From: James Neave [REDACTED]
Sent: 21 March 2014 13:35
To: Peter Cleveland
Subject: RE: WSCC/096/13/F - Ford Waste Treatment Facility - Further Information
Attachments: The Flying Fortress rep obj received 20 Mar 14.pdf; Further info - Appendix 4 (Highways).pdf; Further info - 5. Drawing DG_ES_FOR_R23_02 (Flying Fortress fencing).pdf; 11 09 03.pdf; IMG_1105.JPG; IMG_1106.JPG

Subject: WSCC/096/13/F - Ford Waste Treatment Facility - Further Information

Project: TE1093 Circular Technology Park, Ford Airfield
Date: 26th February 2014
Author: R Spriggs

Title: Response to Highway Comments

REVISION			
PROJECT		Proposed conversion of Grain store building, Ford Airfield	
SUBJECT		Block Plan and Location Plan	
SCALE	DATE	DRAWING No.	
1:1250 & 1:500	Feb 2011		
DRAWN	CHECKED	11 / 09 / 03

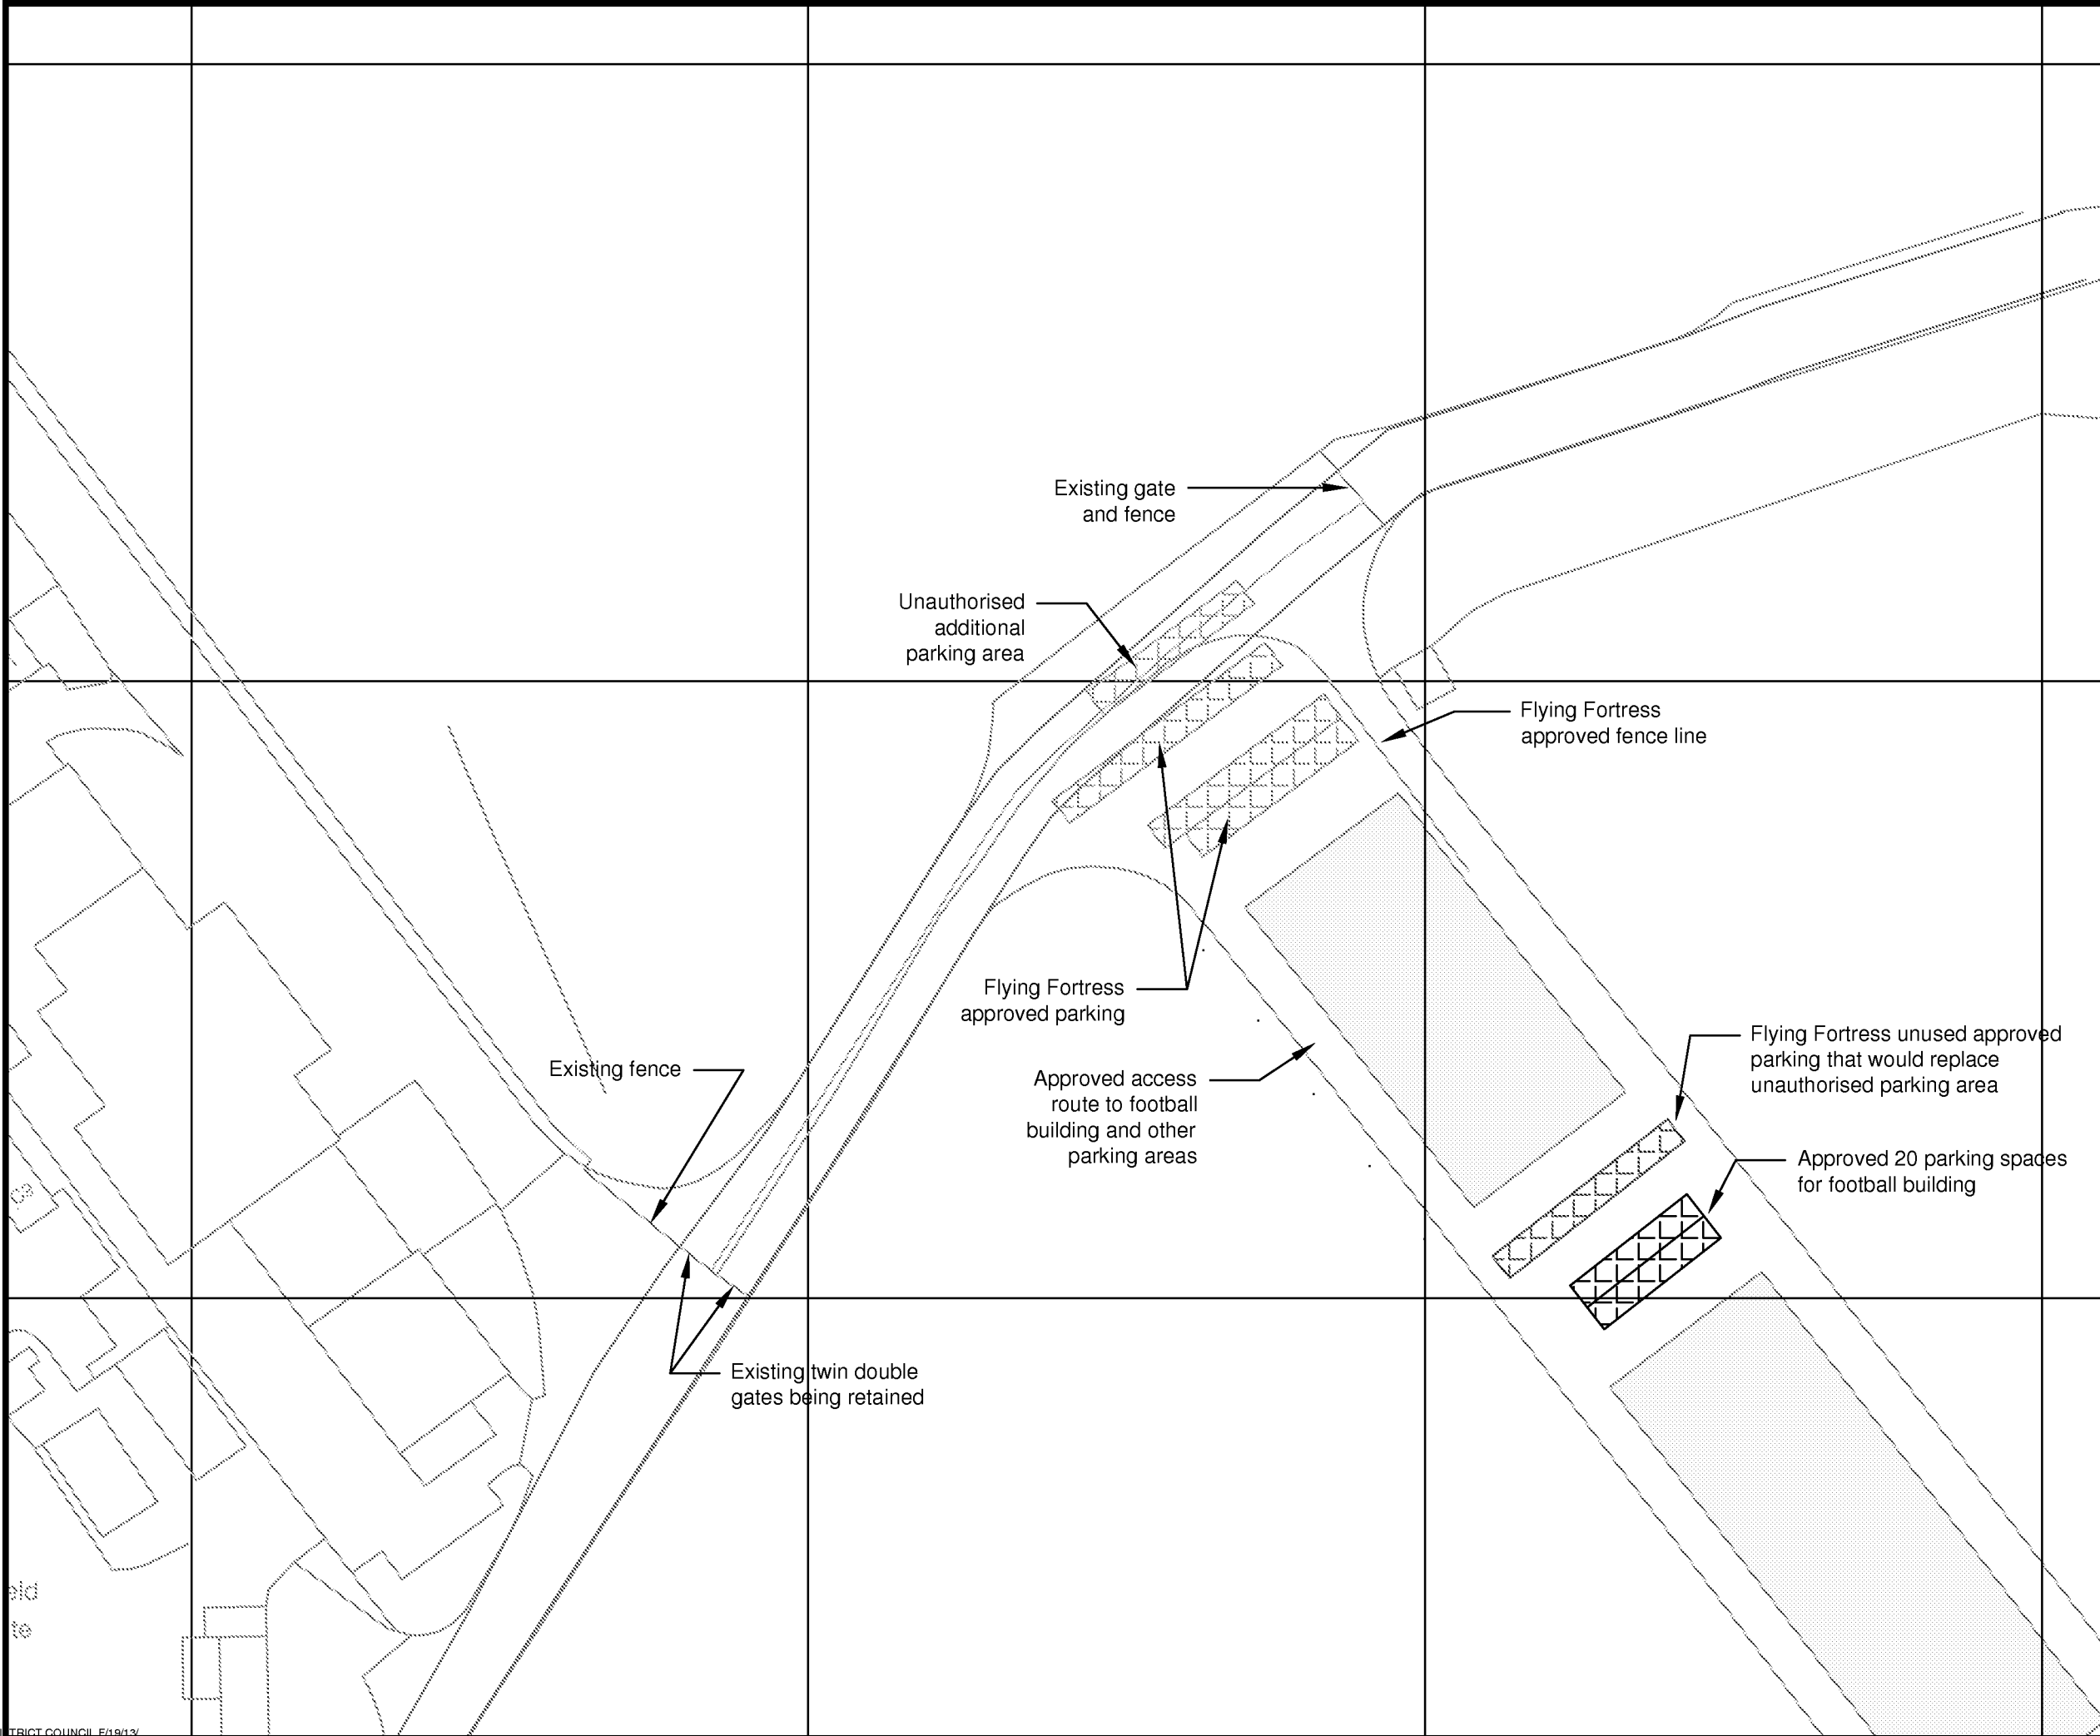
Please can you confirm whether this plan (David Bennett 10353/021) is the approved parking layout for the FF, and 11/09/03 the approved plan for the indoor football. Can you also advise if Arun DC need/intend to regularise the parking arrangements given that the existing layout on site does not appear to represent the approved schemes.

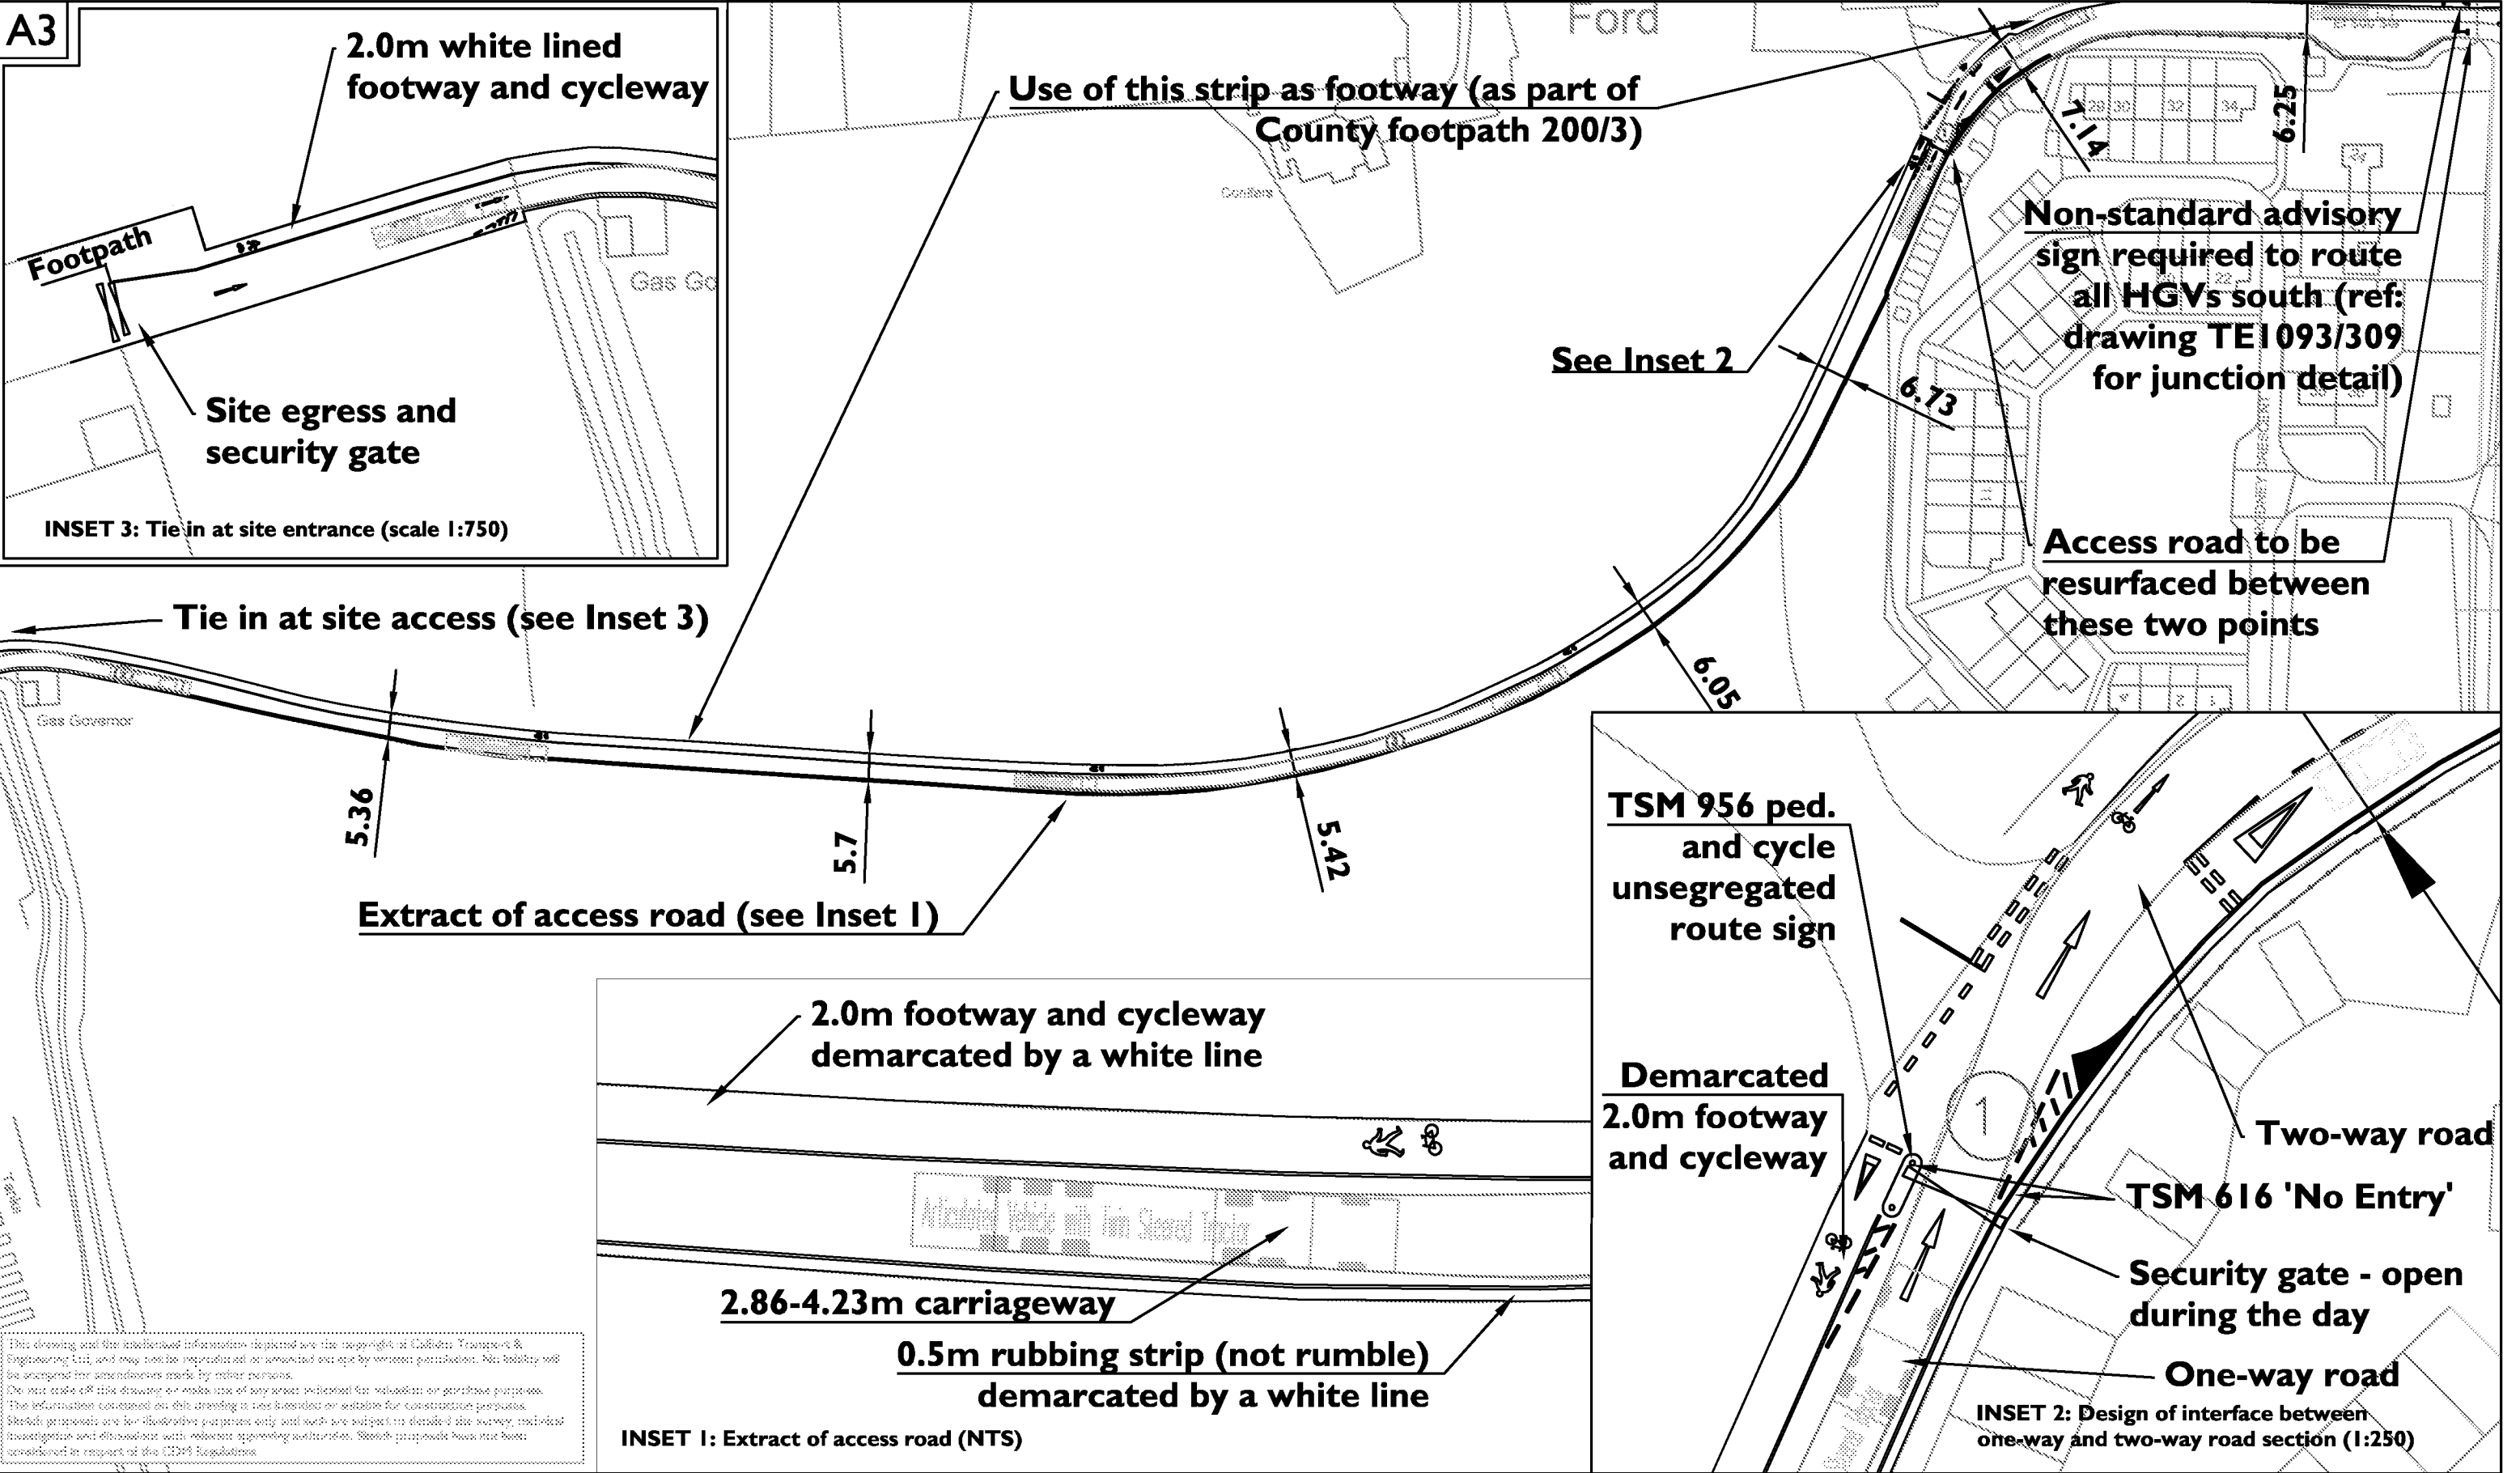
13. The access road from the site is an existing concreted private road. However, we have taken the opportunity that this development affords to improve the access road design for the benefit of pedestrians and cyclists who will be working at the site, and for leisure walkers who might want to use County Footpath 200/3. A revised design, taking into account the Highway Authority's comments where achievable, has been prepared and is shown in drawing TE1093/308 Revision C.
